January 31, 2018

Site: Desert Sands

Re: Drainage Ordinance (14-5-2-1) Violations for Erosion and Sediment Control and Construction Site Waste(s)

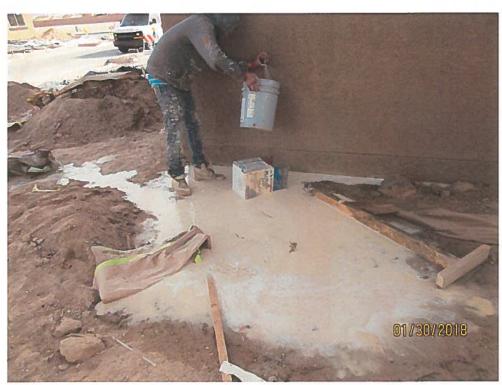
Wash-out on lot.

- 1. Remove all instances of wash-out.
- 2. Provide acceptable wash-out facilities and have workers use them. An Outpak(s) may be a good solution.
- 3. Provide adequate sediment BMPs on all lots with paved streets and curb and gutter. Adequate BMPS are: silt fence, cut-back behind the curb, or filter/mulch socks. A cut-back detail accompanies this letter.
- 4. Remove sediment and trash from gutters and paved streets.
- 5. Remove trash from subdivision drainage outfall. Removing tree shown in picture is optional,

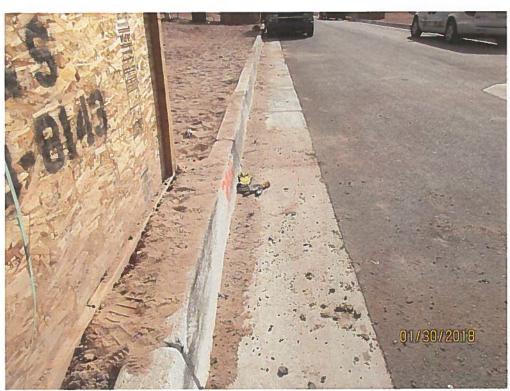
Sediment and trash in gutter. Inadequate BMP on lot(s).
